| Engineer: Barge Design Solutions, Inc. | Engineer's Project No.: 34808-60 |
| Project: 2021 WWTP Improvements | Contract Name: |

Date of Issuance: 4/3/2025 Effective Date: 4/3/2025
 Owner: City of Mount Pleasant Owner's Contract No.: -
 Contractor: BH Craig Construction Contractor's Project No.: -
 Engineer: Barge Design Solutions Engineer's Project No.: 34808-60
 Project: 2021 WWTP Improvements Contract Name: -

PROPOSED SITE PLAN

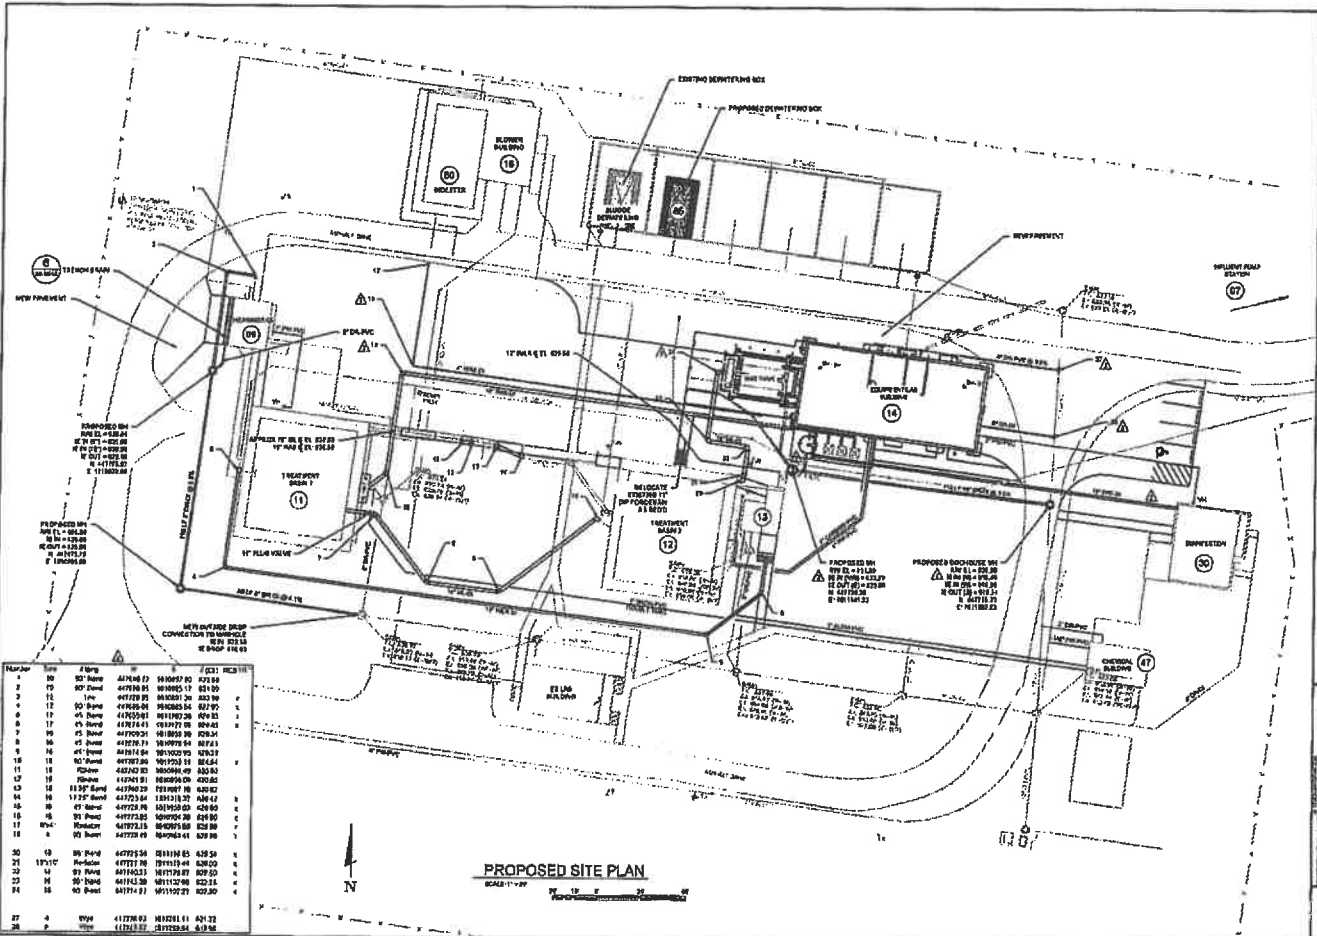
Description: Install piping from the existing IMLR 12" DIP at the northern side of Treatment Basin 1 to the existing 12" Influent DIP north of the Headworks. Temporary piping to be 8" in diameter and installed with approximately 30" of cover and no intermediate high points. The connection to the existing IMLR pipe shall be coordinated with the City and the shutdown of the IMLR system shall be less than 8 hours. See attached sketch for additional details.
